Broussard Planning and Zoning Commission Meeting
416 East Main Street
Broussard LA 70518
Thursday, June 10, 2021
6:00 p.m.

Broussard Planning Marteau Estate Commercial/Residential Development

Whispering Meadow Phase III Residential Development 2021002-008

Broussard Planning Sabal Point

Marteau Estates

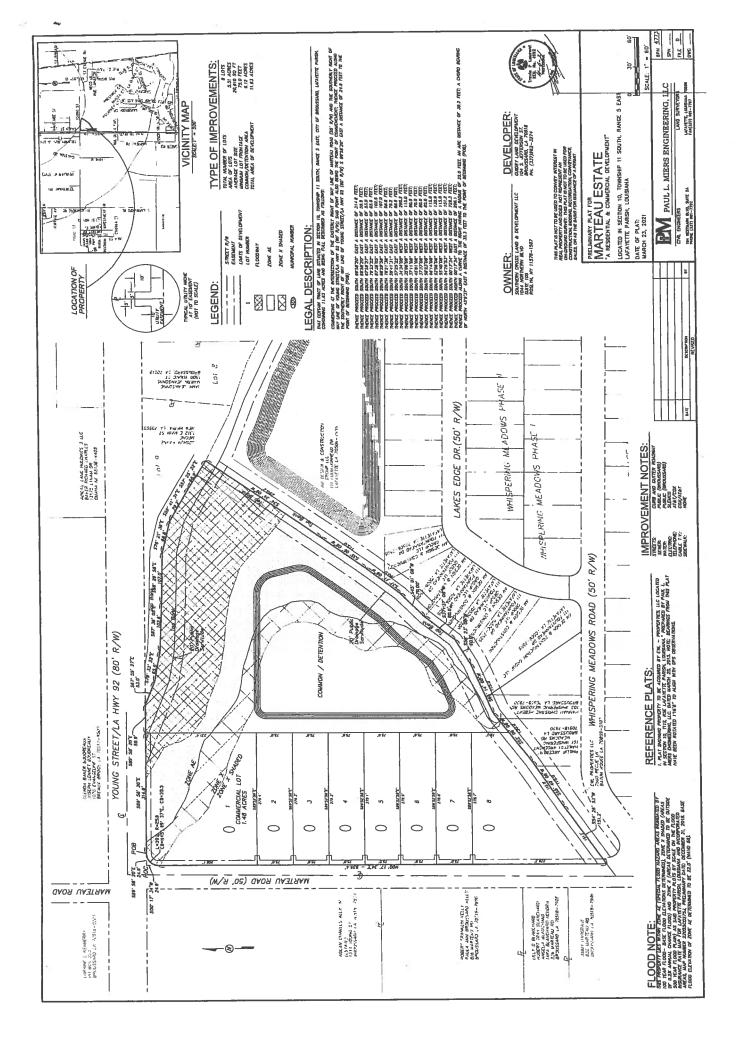
- 1. The property under consideration at this time is not located within the corporate limits of the City of Broussard. The Engineer of Record for the developer has indicated that the developer intends to annex the property into the city. Preliminary Plat approval is contingent on and effective upon annexation of the property into the city.

- 2. This proposed subdivision is to divide a 11.63 acre tract into 7 single family residential lots and one commercial lot.
- 3. Portions of the property are located within Zone AE and within a Regulatory Floodway. Fill placement or construction which would impede the floodway is prohibited. Structures constructed within Zone AE shall have a finished floor elevation 1' above the Base Flood Elevation minimum.

- 4. An additional 5' R/W shall be dedicated along Marteau Road.
- 5. A 15' sidewalk, drainage and utility easement shall be provided along Marteau Road and LA

- 6. 20' setbacks shall be required along Marteau Road and LA Highway 92.
- 7. Residential traffic from Lots 2-8 will not be permitted to back onto Marteau Road. Builders will be required to provide driveway access to these lots to facilitate this and will provide site plans, acceptable to the permitting department, at the time building permits are obtained.

- 10. It is the sole responsibility of the developer to provide water and sewer to the point of service of each lot.
- 11. Marteau Road shall remain open ditch, a note to that effect shall be placed on the plat.

- 12. A profile of Marteau Road, proposed regrading and culvert sizing chart for each lot shall be provided as part of the construction submission.

Whispering Meadows Phase III

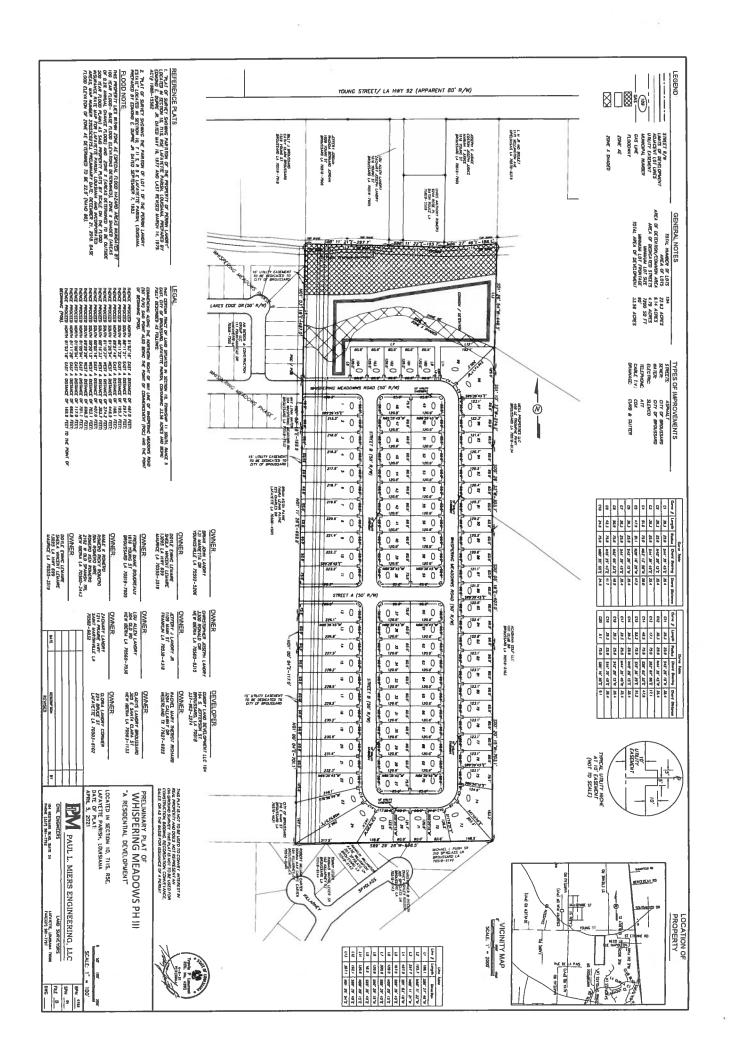
- 2. This proposed subdivision is to divide a 33.56-acre tract into 104 single family residential lots.
- 3. Portions of the property are located within Zone AE and within a Regulatory Floodway. Fill placement or construction which would impede the floodway is prohibited. Please identify the limits of the Regulatory Floodway.

- 14. Please identify the use of the "15" utility easement to be dedicated to City of Broussard."
- 15. Please identify the lines shown along the western border of the subdivision.

TO: Various Property Owners Adjacent to Section 5, T11S, R5E Lafayette Parish Nearest intersecting street(s): W. Fairfield and S Bernard Road Sabal Point

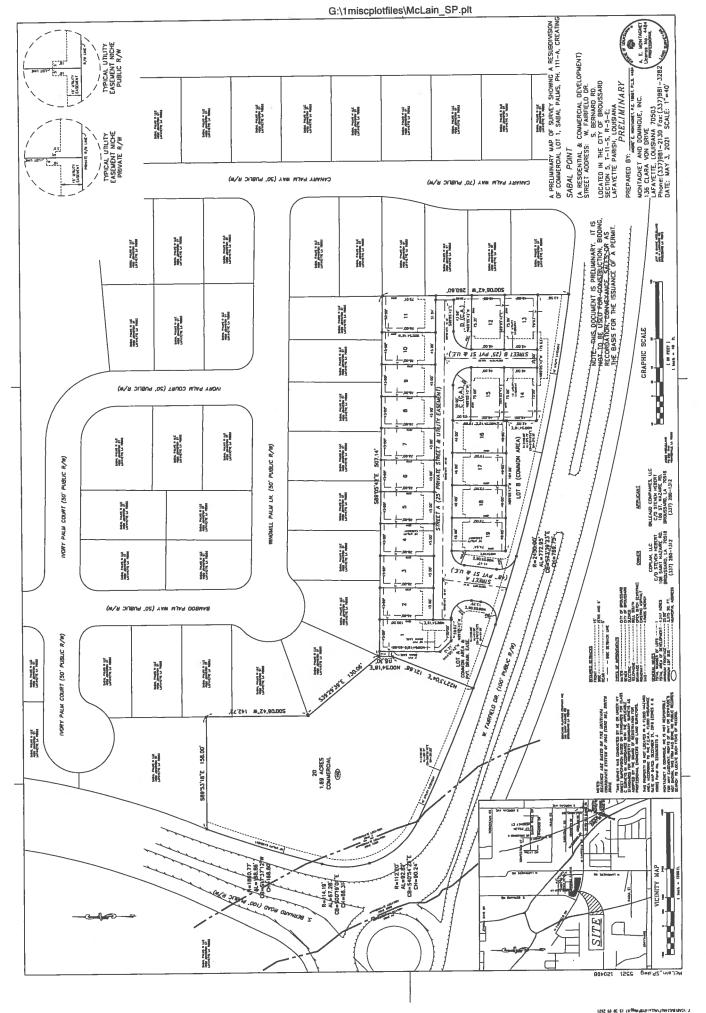
- 1. This proposed subdivision is to divide a 4.274 acre tract into one commercial lot and 19 zero lot line residential lots.
- 2. The developer has requested that the front setback be reduced to 15'. This would place the residential foundation at the edge of the utility easement. We recommend approval of this request only if the following conditions are met.

- 3. The developer has also requested a waiver of the street width from 28' to 25'. Broussard Subdivision regulations require a minimum 28' width for private streets. We do not recommend that the Commission grant this waiver due to emergency access concerns.

- 4. Preliminary layouts of this development were shared with City staff during a preapplication meeting. That layout indicated two driveways to the commercial lot and an additional driveway to the residential lots. Please be informed that all of these proposed

driveways are in exceedingly close proximity to the roundabout. During this meeting City staff recommended eliminating the southernmost commercial drive and utilizing residential drive as a common access; the developer has chosen not to do this. Due to the proximity of the roundabout this will require additional analysis by a Traffic Engineer and may trigger requirements in addition to the requirements herein. This analysis may be performed during the plan review process.

- 5. The access point for the residential area shall be right turn in and right turn out only and shall be channelized. The developer shall be required to install some type of median barricade, acceptable to the City, to prohibit median crossover access to or from the subdivision entrance.

- 6. The developer shall be required to provide an end treatment, acceptable to the City, at the termination of Street B to prohibit access to West Fairfield.

- 7. The current configuration of the streets would require Fire Trucks or other large vehicles to back out onto West Fairfield, this is unacceptable. The developer shall be required to extend Street A to the western border of the residential area to facilitate a Fire Truck or other large vehicle turn around. Due to Planning Commission plat review time constraints Fire Department access will be required to be thoroughly evaluated during the plan review process. Access to this development shall be acceptable to the Broussard Fire Department.

- 9. Please revise the utility easement along South Bernard and West Fairfield as a 15' Sidewalk, Drainage and Utility Easement.
- 10. No determination has been made at this time as to the downstream capacity of the city sewer system. The developer may be required to participate in infrastructure improvements with regard to the city's ability to accept sewer flows from the proposed development.

- 18. Please correct the note indicating the number of lots.

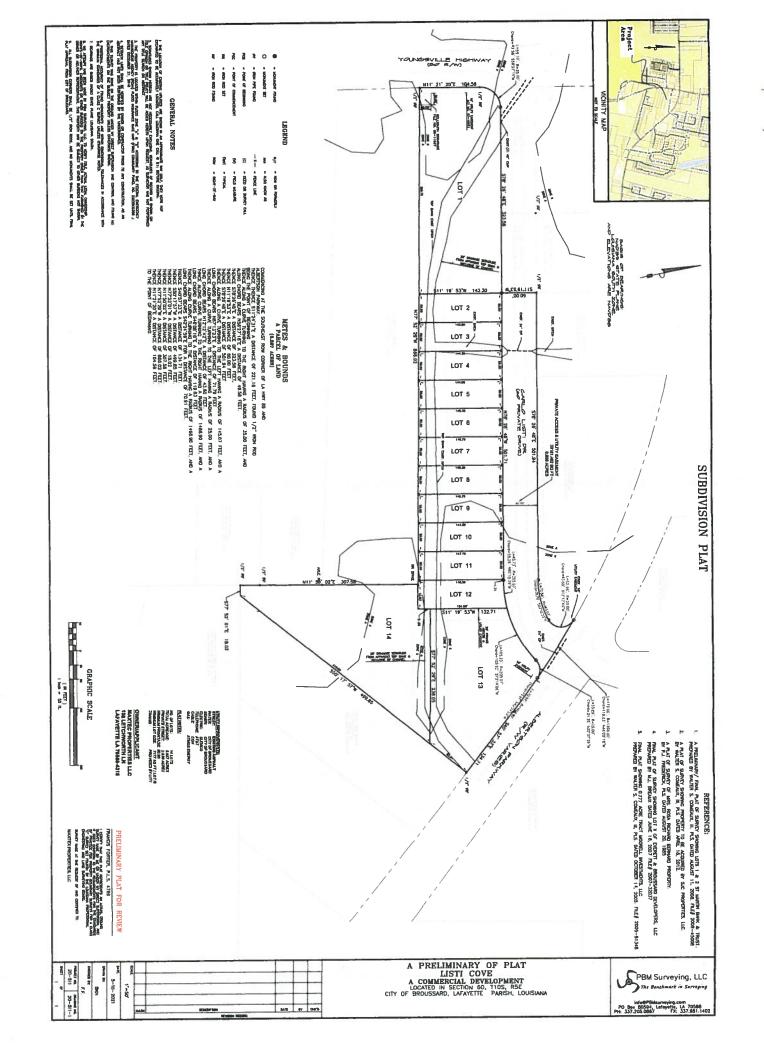
- 1. This proposed subdivision is to divide a 5.897-acre tract into 14 commercial lots.
- 2. Please add the name and phone number of the applicant.
- 3. Note that the strip of property south of the ditch on Lots 1-12 is part of the drainage easement.

- 4. Provide a drainage easement between Lot 3 & 4, 20' from bank of ditch on either side and inclusive of channel.
- If Carlo Listi Drive drainage system drains adjoining properties change the note from Private Access & Utility Easement to Private Access, Utility & Drainage Easement.

- 6. The servitude providing access to Lot 14 must be 28' wide.
- 7. Additional utility servitudes may be required along Carlo Listi Drive, to be determined during plan review.

Broussard Planning Ambassador Common Residential Development 2021002 011

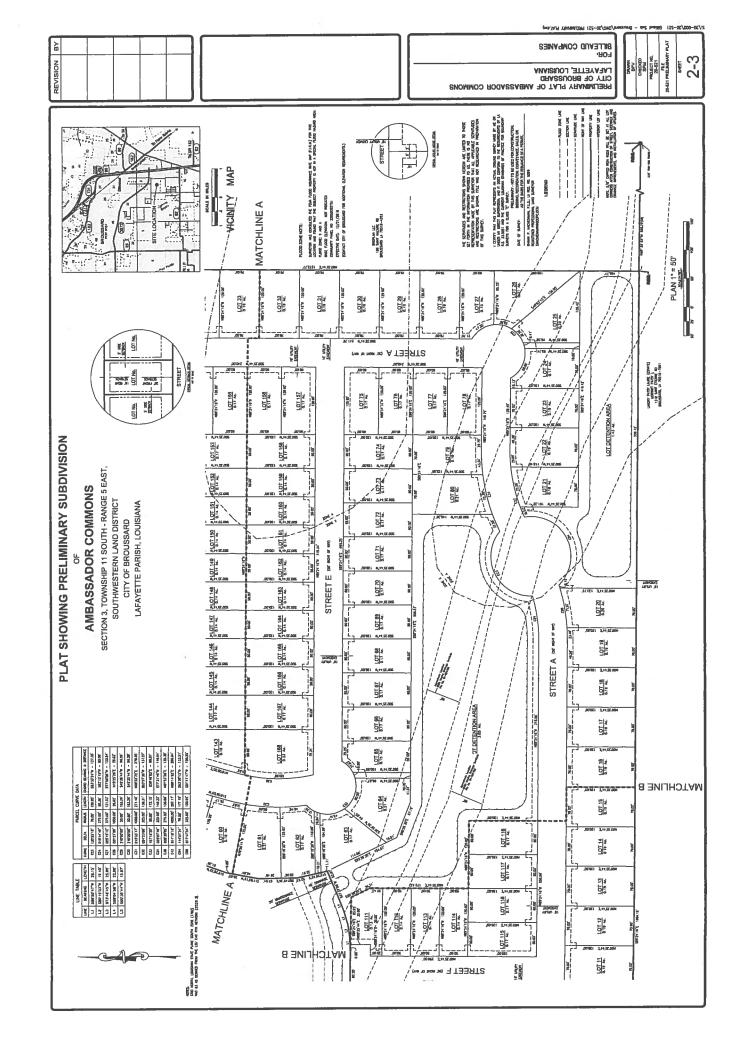
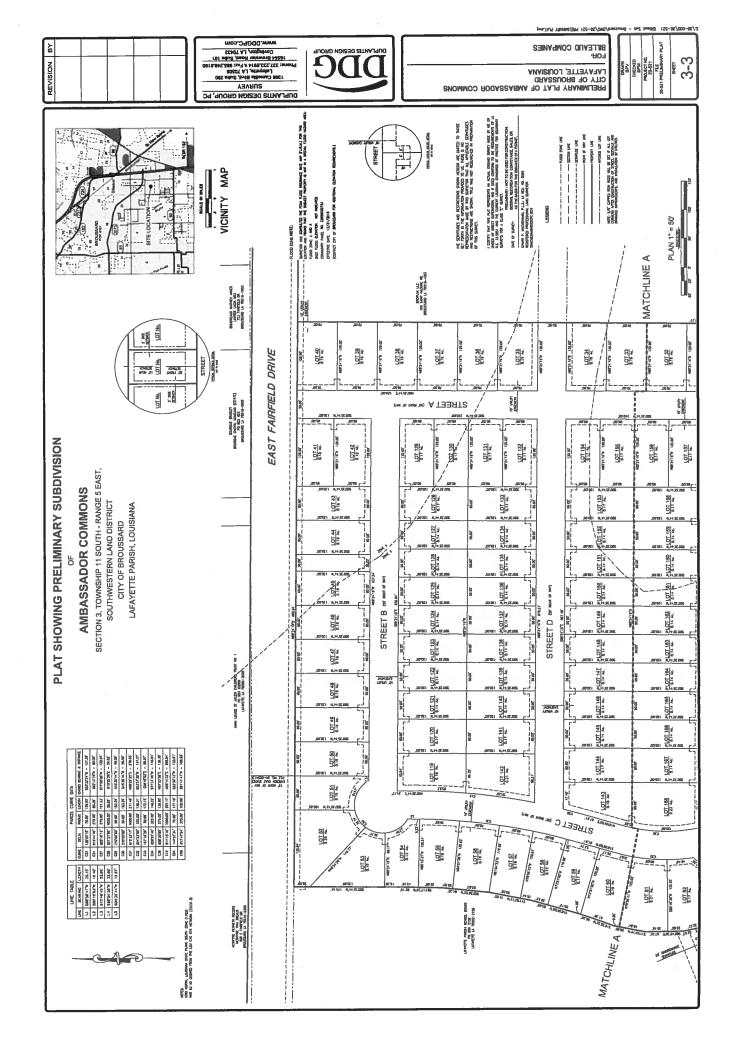
- 1. This proposed subdivision is to divide a 27.903 acre tract into 168 residential lots.
- 2. Please resubmit this plat on one sheet, a 1"=100' oversize drawing is acceptable.

- 3. Provide the name, address and phone number of the owner and developer on the plat.
- 4. Indicate the plat type (single family residential).
- 5. Provide a legal description of the property being subdivided.

- 6. The notes show the total area of lots, show the total acreage.
- 7. Show the distance to the nearest intersecting street.
- 8. Show the date of preparation of the Preliminary Plat.

- 9. Show edge of asphalt on Marteau and East Fairfield.
- 10. Provide additional R/W along Marteau measuring 30' from centerline of existing road.
- 11. Provide a 15' sidewalk, drainage and utility easement along Marteau and East Fairfield.

- 13. Provide 25' fillets at all intersections including Marteau and East Fairfield.
- 14. Place a note on the plat that no fences are permitted within or across city servitudes.

- 17. Contact the Broussard Post Office to determine the need for a mail kiosk.
- 18. Provide a stub street to the south.

- 28. Provide a 1' reserve strip on all lots adjoining existing public roads.
- 29. A Louisiana Department of Health permit is required prior to commencement of construction.

- Regarding the request for an additional 5' servitude along the back of lots on E. Fairfield, the additional servitude would impact the function of the lots; therefore, unfortunately we will be unable to accommodate the request. There is currently a 10' utility servitude along E. Fairfield.
- Regarding the request for 25' ROW radii at all street intersections, we will make this change on the revised plat.
